SURVIVAL TECHNOLOGY
**Marine Mk IV Liferafts — Hull :
*Introduction of design changes***

23/24	Marine Mk IV Liferafts — Hull : Introduction of design changes		
	Version 1:	Dec/25	Page 1 of 17

Figure 3
Updated webbing and fabric materials

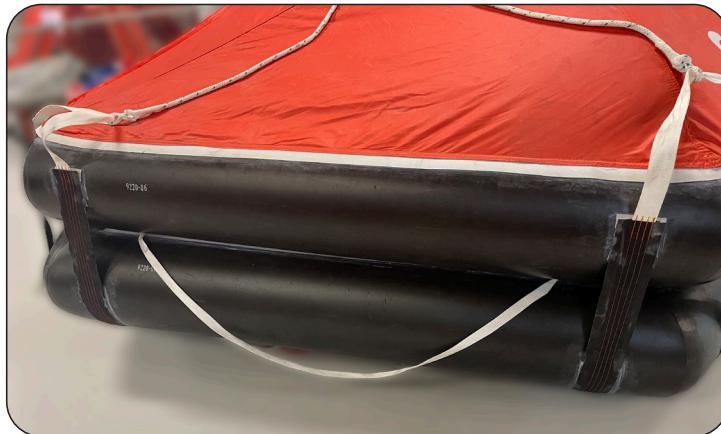
- Both webbing and fabric materials have been updated to support improved performance (Refer to **Figure 3**).

Figure 5
Updated light attachment point

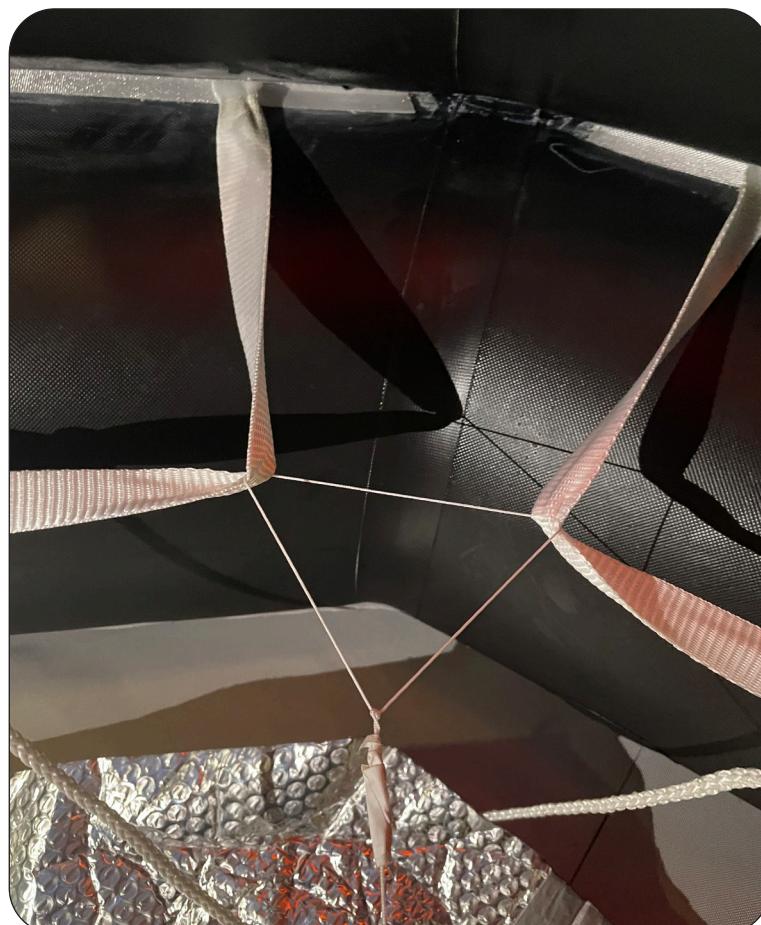
- The attachment point for the light activation line has been moved from the loop patch to the adjacent liferaft lifelines (Refer to **Figure 5**).

Figure 9
Activation line attachment point

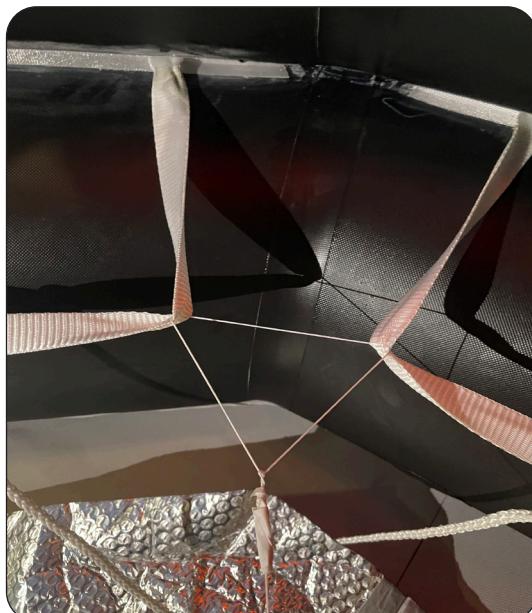
- (1) Cut the correct length of activation line (50 lb cord) (Refer to **Table 1**).
- (2) Loop the activation line around two adjacent lifelines.
- (3) Use a bowline knot to tie the activation line (Refer to **Figure 9**).
- (4) Wind self-adhesive tape around the flying ends to hold in position.

Figure 10
Attachment point of activation line for 4 person liferaft

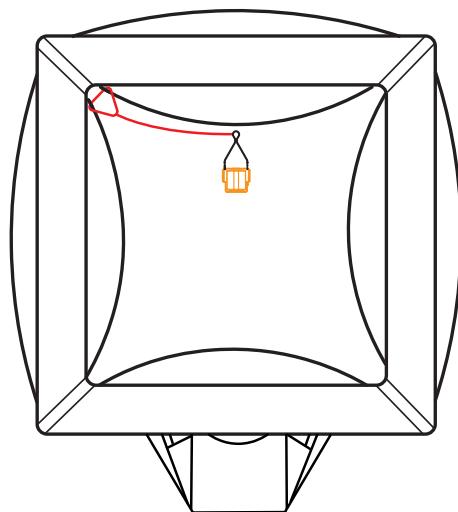
Liferaft capacity	Cut length (mm)
4	850
6	500
8	500
10	1200
12	1200
16	1700
20	1800
25	1950
